Serial No.: 10/078,883

For: **Boundary Scan With Ground Bounce Recovery**

PRELIMINARY AMENDMENT

FIG. 8

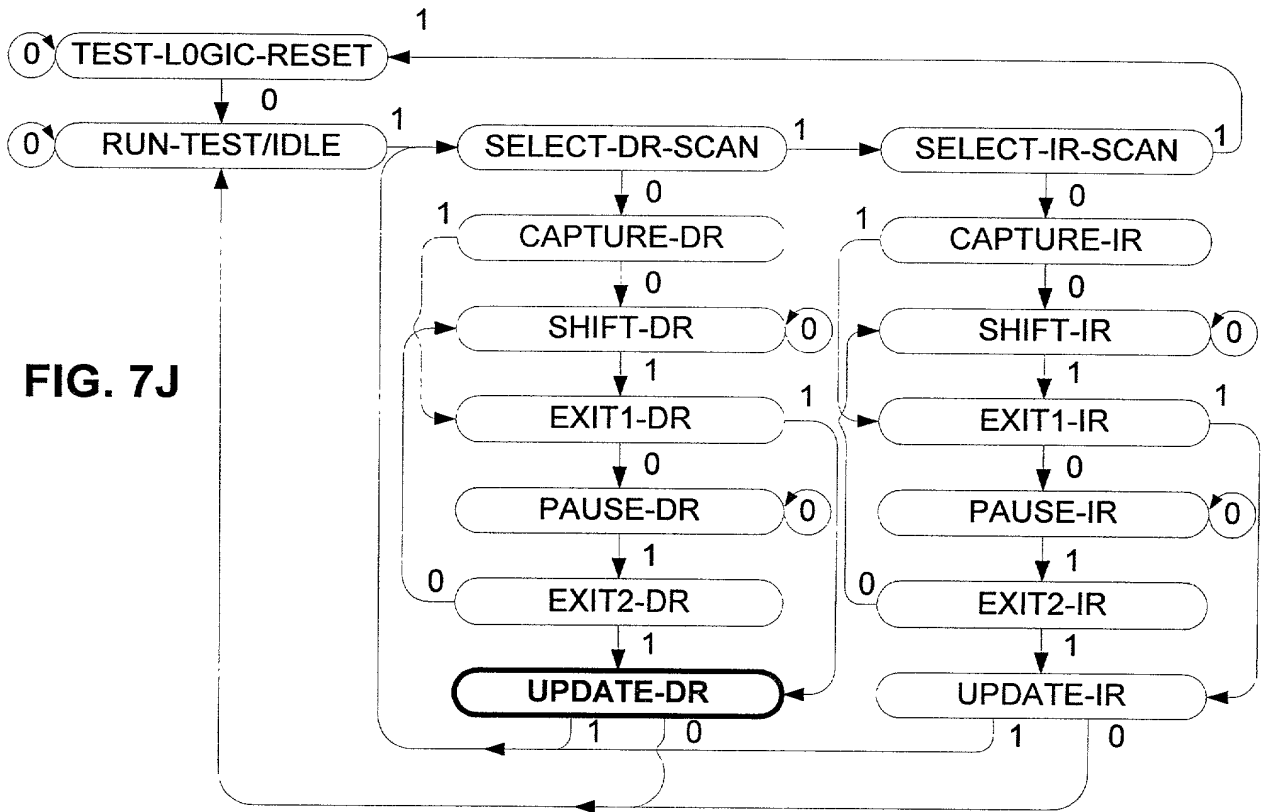
Please approve the proposed drawing changes shown in red on the attached sheet wherein FIG. 7K has been relabeled as FIG. 8 in order to conform with the written specification.

was mislabeled as FIG. 7K. Accordingly, proposed drawing changes are attached to this amendment in which FIG. 7K has been relabeled as FIG. 8. In addition, references to FIG. 7K in the specification have been amended to refer to FIG. 8 in order to conform the drawings with the written specification. It is respectfully submitted that these amendments do not add new matter to the present application.
